Interim Drainage Report
for
Windingwalk Grading
at
Meridian Ranch

Comments provided by EN,
2/16/18

PCD Project No. EGP-17-001

FIGURE 4

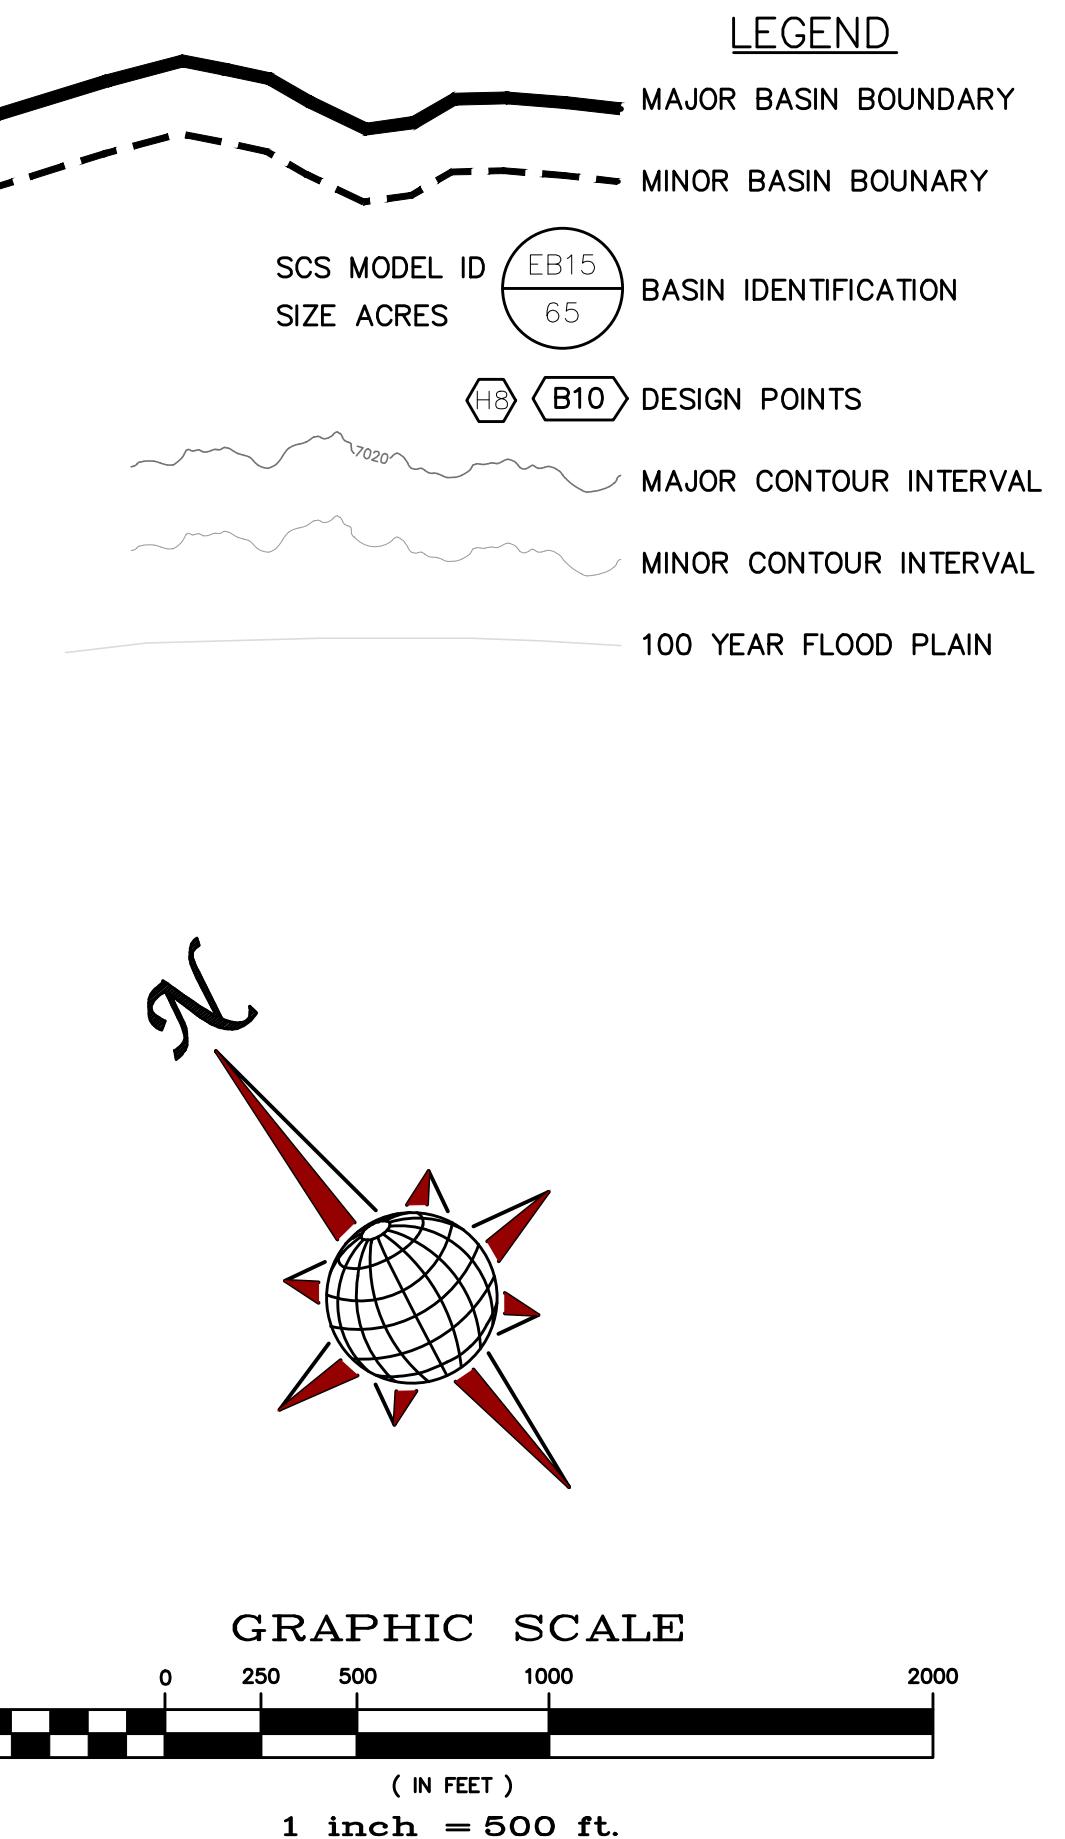
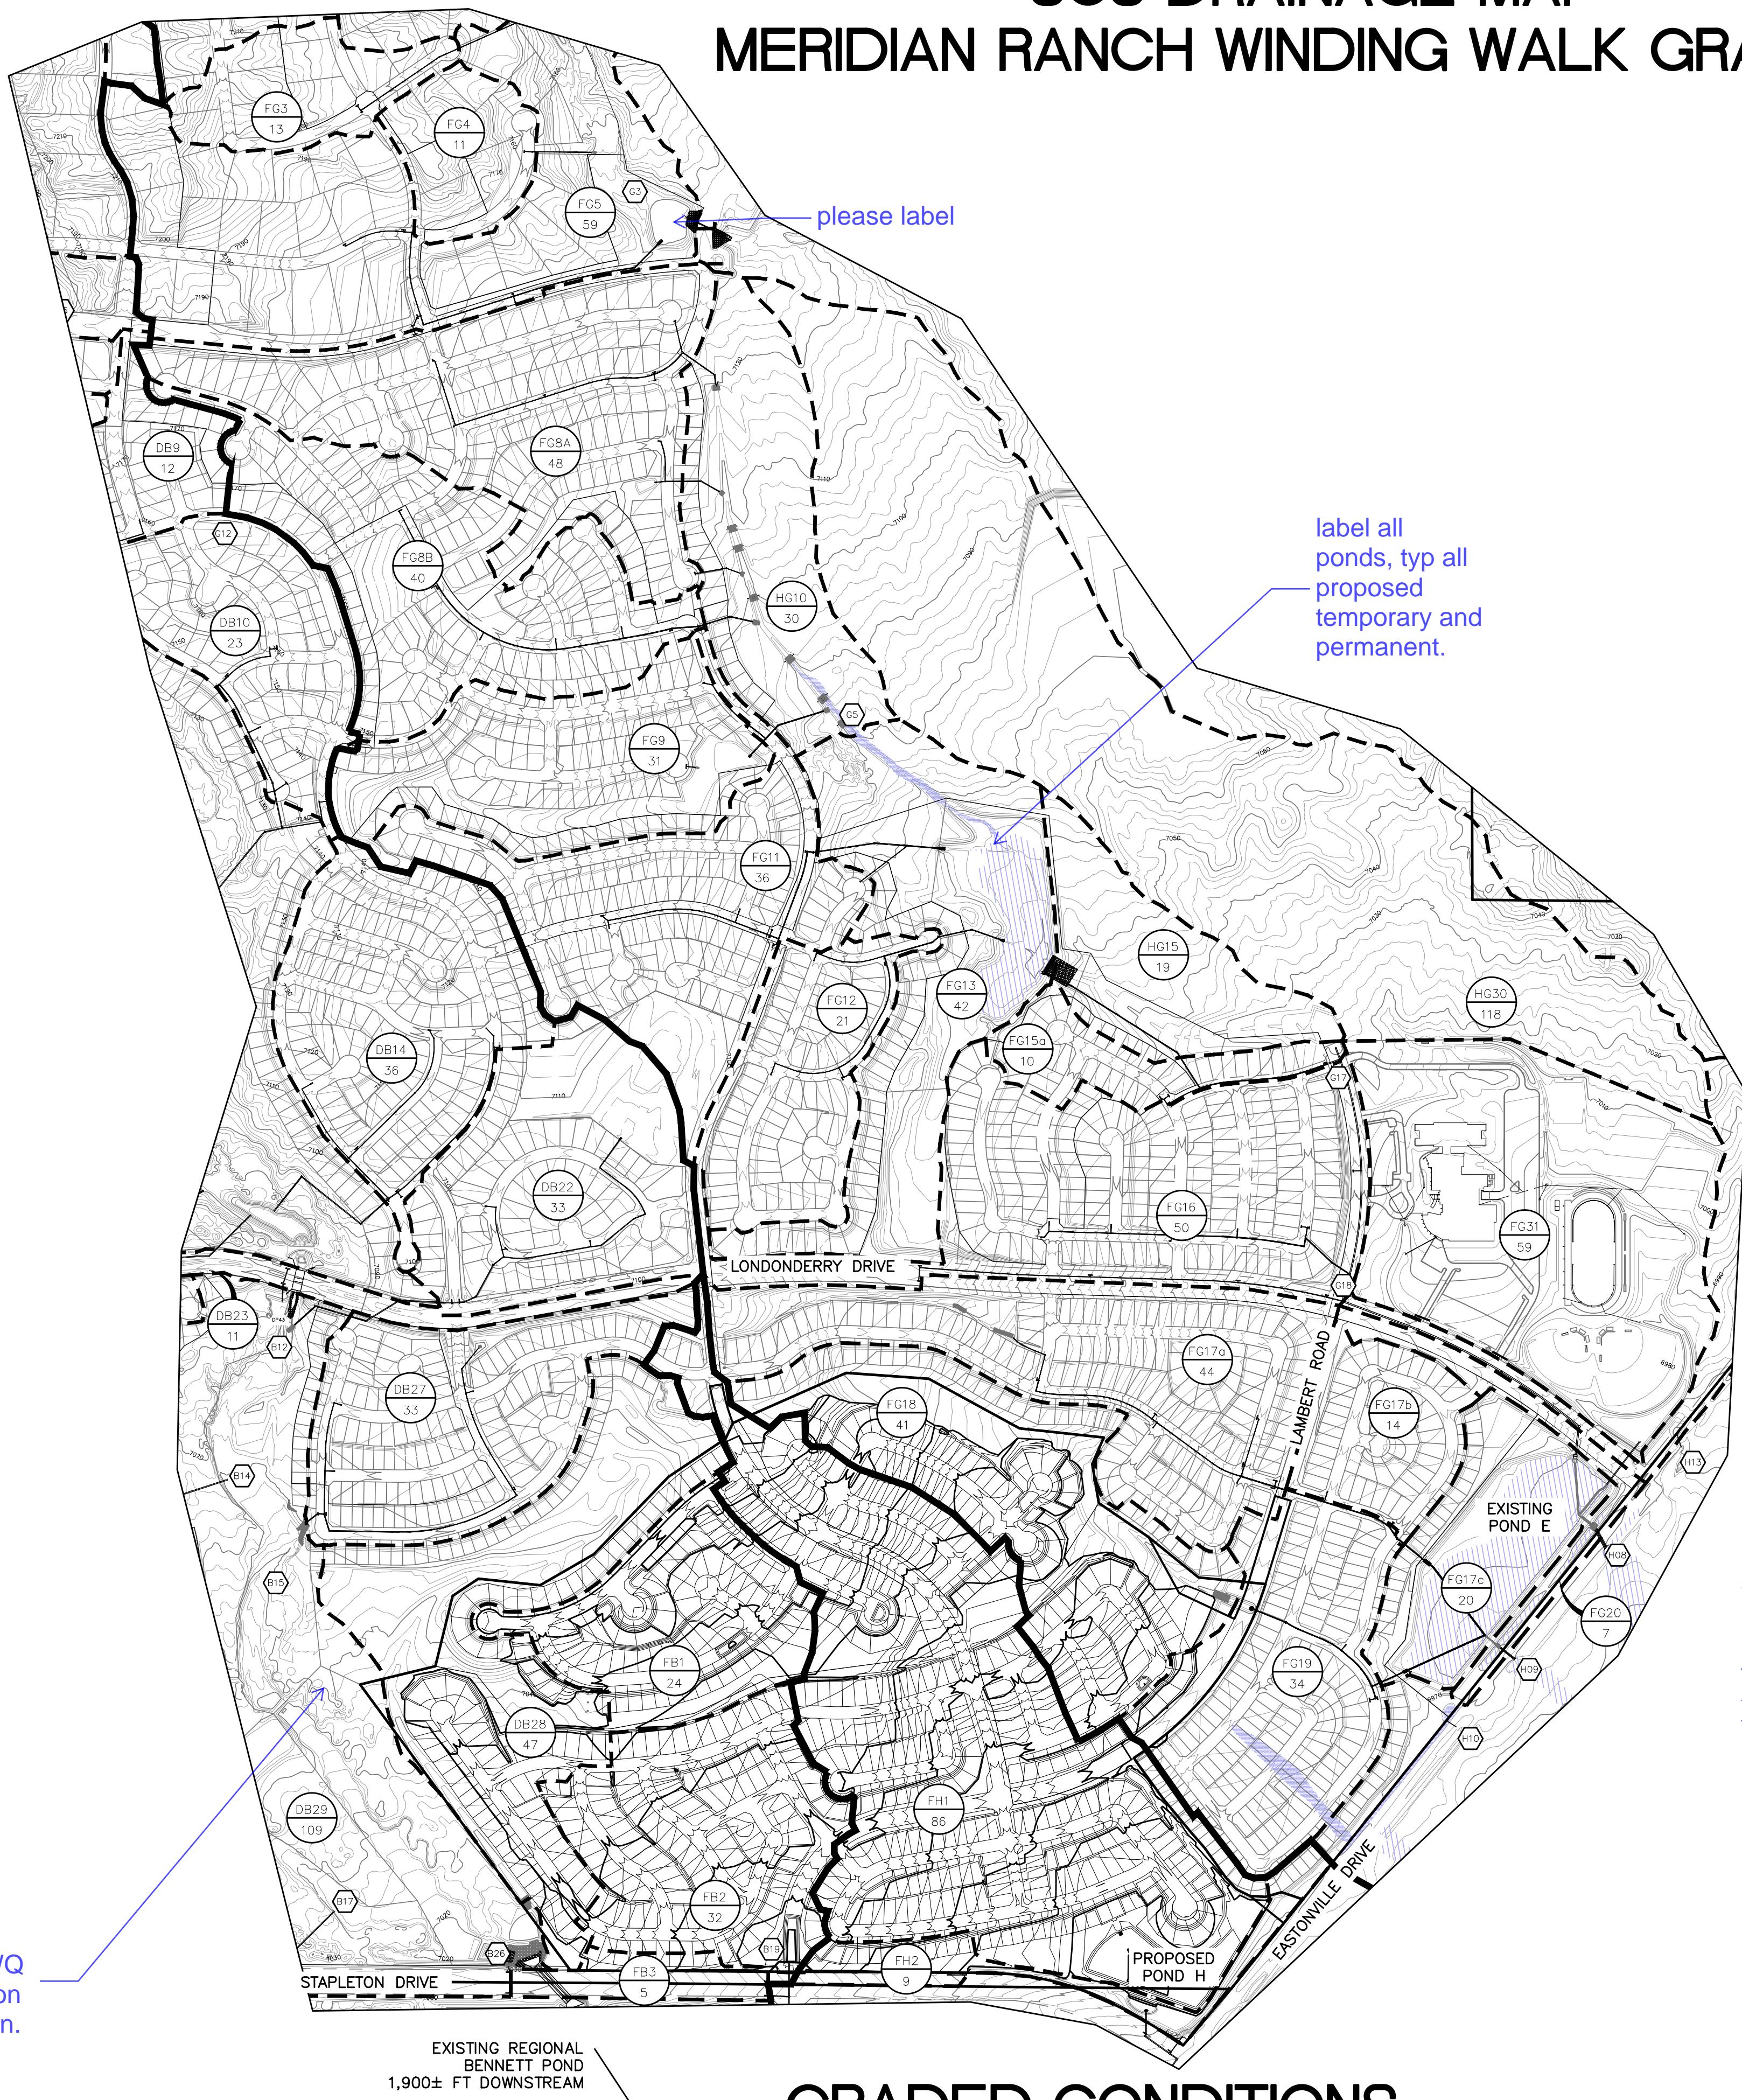
Figure 4: Meridian Ranch SES Calculations – Historic Conditions Map, Figure 5: Meridian Ranch SES Calculations – Future Conditions and Figure 6: Meridian Ranch SCS pond has been designed for WQ and or detention for any or all of these basins, please call out clearly. Please call out the proposed Bennett Ranch basin pond.

call out
graded
future
condition
map
